Shenzhen Hollyland Technology Co., Ltd.

Ref: FCC Class II Permissive change for FCC ID: 2ADZC-M71T

This is to request a Class II Permissive change for FCC ID: 2ADZC-M71T originally granted on 2025-03-09(date).

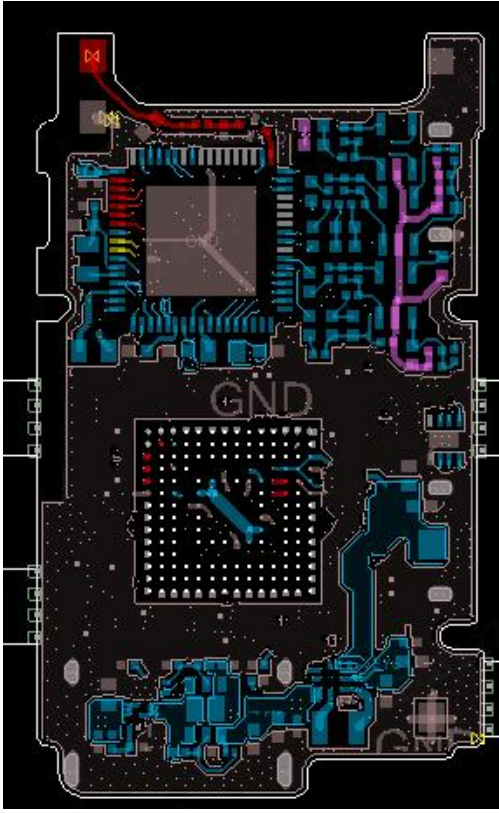
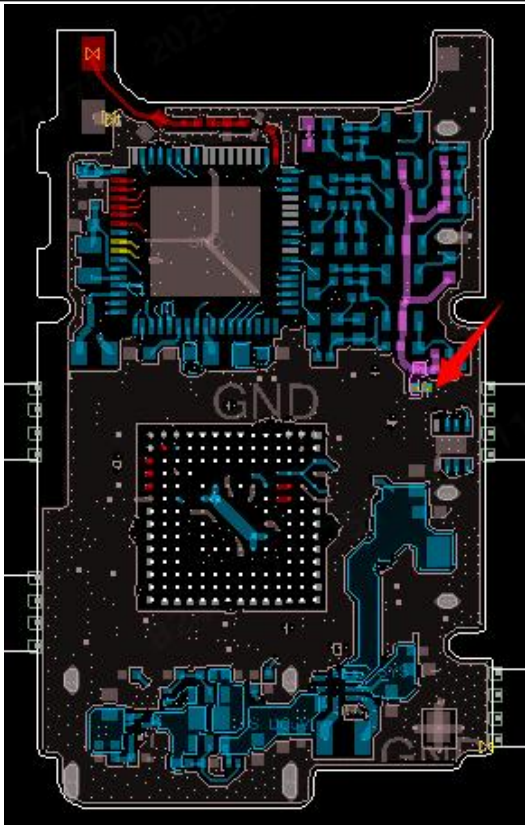
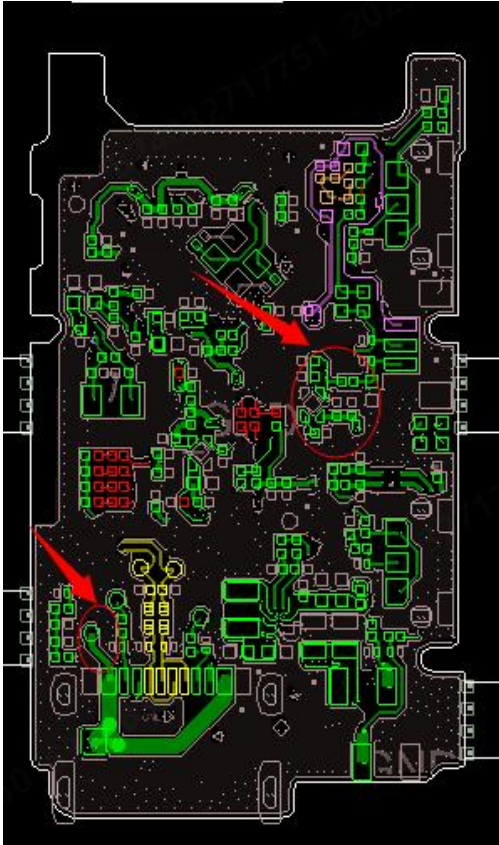
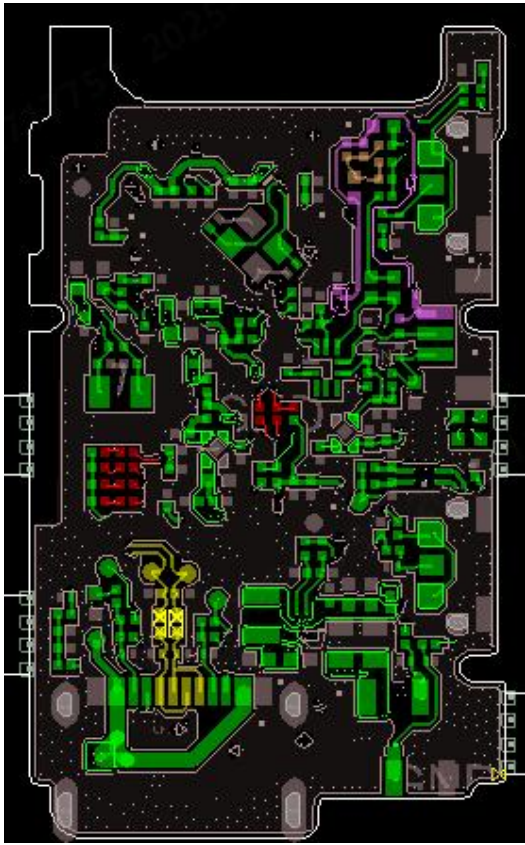
before change	after change
change point 1		R84 is NC, R85 is 0R, and a 0R position is added to the BOTTOM layer <i>Change 1: Optimize audio metrics R35 and R37 to 15K.</i> <i>Change 2: To achieve the USB C MIC function, the original uart tx of the V38 USB C port was changed to MIC2, and the original uart rx was changed to MIC SEL.</i> <i>R1 and R9 were deleted.</i> <i>Change 3: To achieve the USB C MIC function, an analog switch and bias material were added: U2, R1, R45, R46, R47, R58, C1, C2, C68</i>
change point 2	V38 PCB bottom	V88 PCB bottom
